CURRENT PAGES MARKED-UP TO REFLECT PROPOSED CHANGES TO THE
DONALD C. COOK NUCLEAR PLANT UNIT NO. 1
TECHNICAL SPECIFICATIONS

The relaxation for centrifugal charging pumps is also applicable to LCOs 3.1.2.3 and 3.1.2.4.

FIGURE 2.1-1 REACTOR CORE SAFETY LIMITS

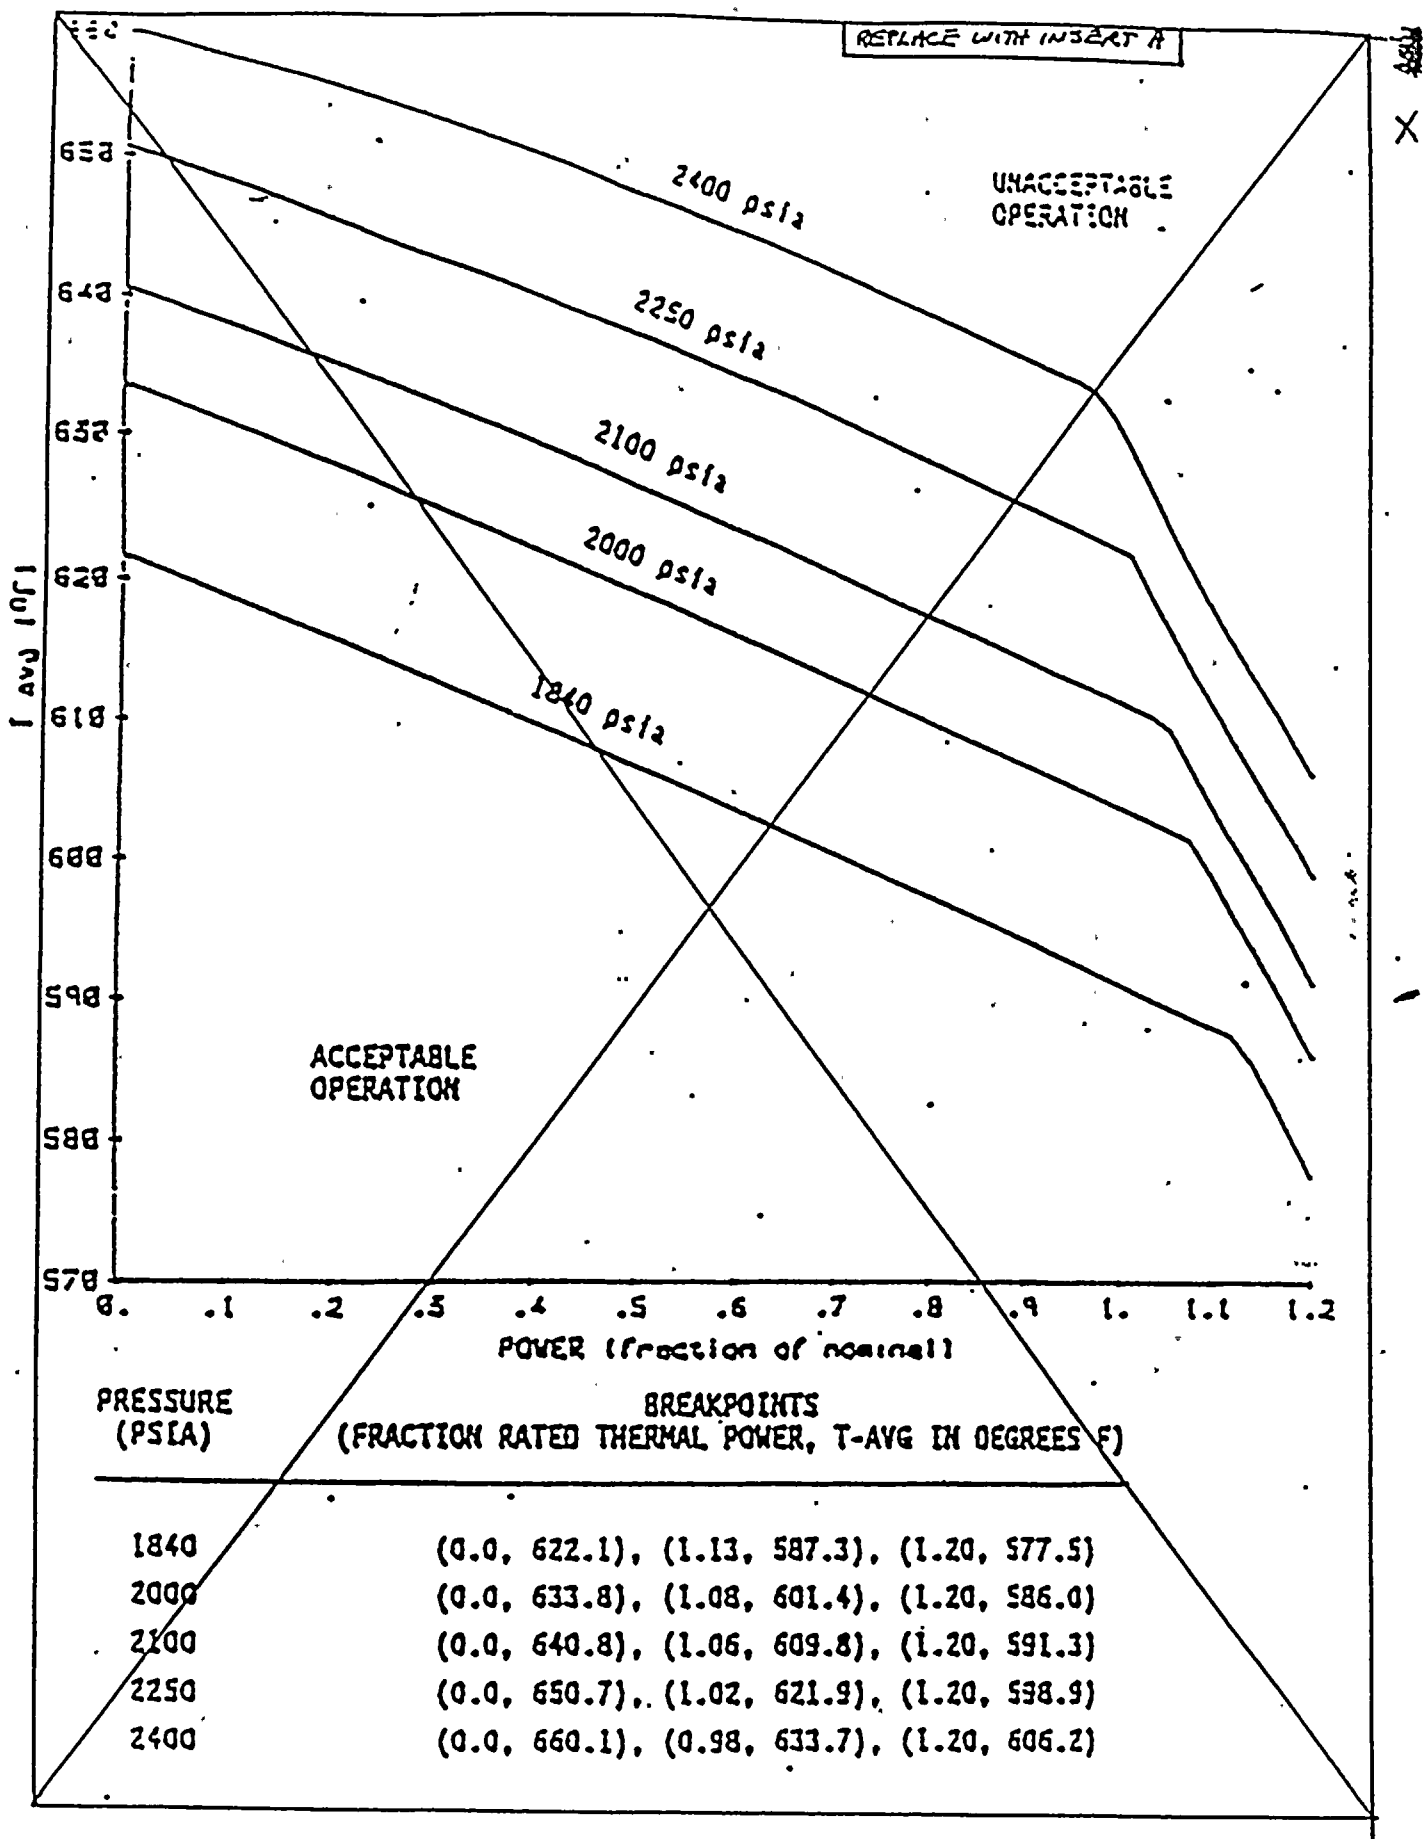
Page	Section	Group	Description	Remarks
2-2	Figure 2.1-1	Margin	Revise Reactor Core Safety Limits	The new thermal design is discussed in Section 3.3.2.1 of Attachment 6, WCAP 14285.
2-5	Table 2.2-1 Footnote	SGTP	Redefine design flow in footnote of Table 2.2-1 to be 1/4 MMF.	MMF for DNB is discussed in Section 3.3.2.1 of Attachment 6, WCAP 14285. T.S. MMF is 1.025 times thermal design flow (TDF). TDF is specified in Section 3.3.3.1 of WCAP 14285. The MMF employed in the DNB analysis is 1.019 times TDF. This was done to support a range of MMF's from 1.019 to 1.025 times TDF as indicated in Section 2.1 of WCAP 14285. Design flow in current technical specification Table 2.2-1 is MMF/4.
2-7	Table 2.2-1	Margin	The upper limit on T' increased to reflect analyses.	The OTDT trip is discussed in Section 3.3.2.1 of WCAP 14285. Details, including T', of the analyzed setpoint are in Table 3.3-3 of WCAP 14285.

<u>PAGE</u>	<u>SECTION</u>	<u>DESCRIPTION OF CHANGE</u>	<u>BASIS</u>
2-2 B 2-1(a)	2.1 Bases 2.1	<p>Core Safety Limits Replace Figure 2.1-1, Reactor Core Safety Limits</p> <p>The safety analysis limit DNBR specified in the Bases for Section 2.1 has been revised from 1.45 to 1.42.</p>	<p>Figure 2.1-1 has been replaced with a new figure based on the latest analyses, reflecting 30% SGTP, reduced rated thermal power, reduced RCS flow, etc.</p> <p>Section 3.3.2.1</p>
2-7 2-8 2-9 B 2-4 B 2-5	2.2 B 2.2.1	<p>OTΔT & OPΔT Setpoints Revise OTΔT and OPΔT Trip Setpoint and Allowable Value notes.</p>	<p>Proposed settings based on new core safety limits and account for instrument uncertainties.</p> <p>Section 3.3.2.1 & Table 3.3-3</p>
3/4 1-1 B 3/4 1-1	3.1.1.1	<p>Shutdown Margin Shutdown Margin limit relaxed from 1.6 to 1.3 % Δk/k</p>	<p>Relaxation based on re-analysis of limiting accident - core response to steam line break.</p> <p>Sections 3.3.4.7 & 3.3.5.6</p>

Figure 2.1-1 has been replaced with a new figure based on the latest analyses, reflecting 30% tube plugging, reduced rated thermal power, reduced RCS flow, etc.

FIGURE 2.1-1 REACTOR CORE SAFETY LIMITS

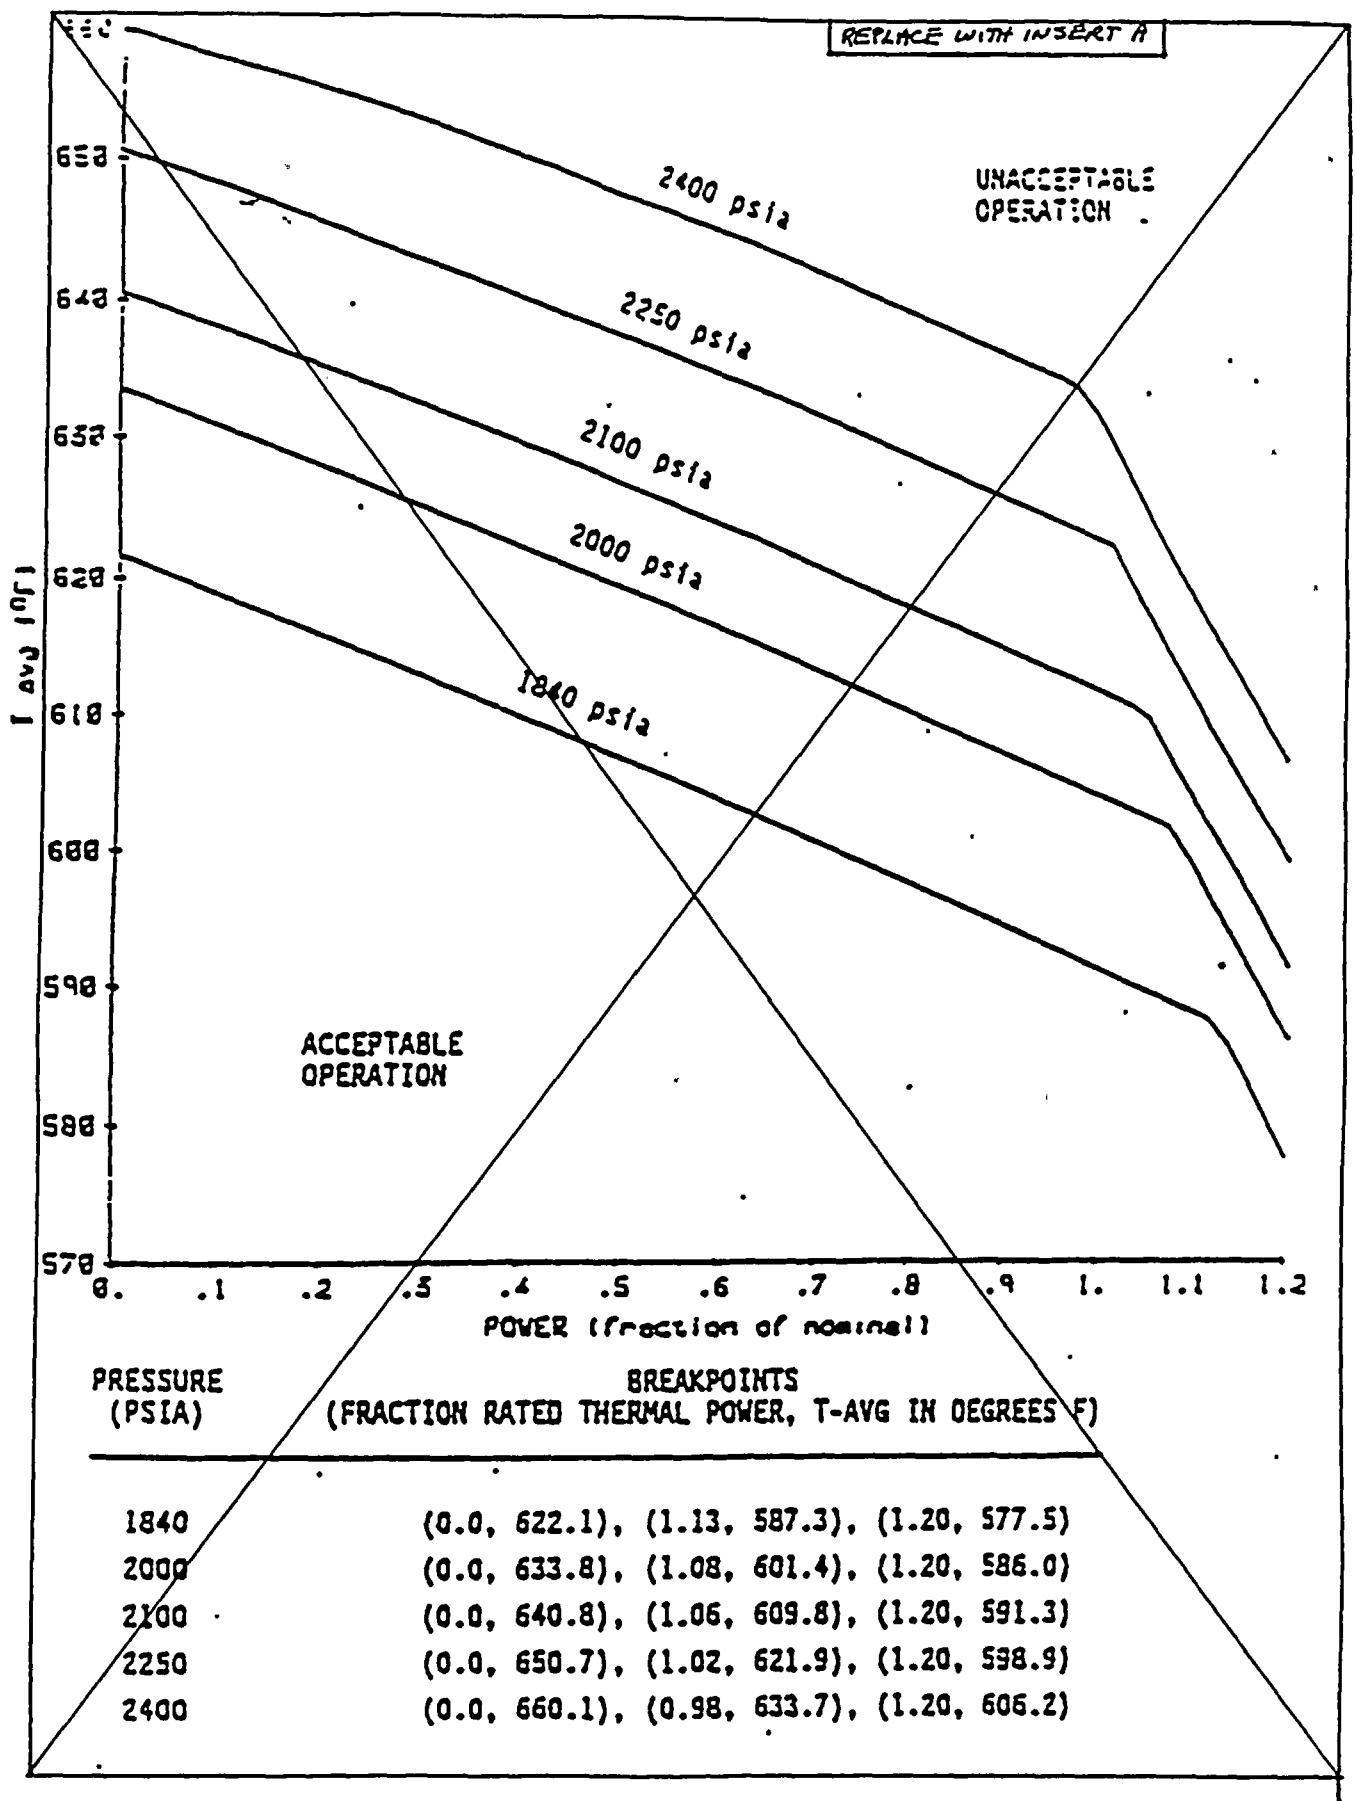
Technical Specification Figure 2.1-1, Reactor Core Safety Limits, shows the loci of points of thermal power, RCS pressure and average temperature below which the calculated DNBR is no less than the design DNBR value and the average enthalpy at the vessel exit is less than the enthalpy of saturated liquid. The figure is based on the enthalpy hot channel factor.
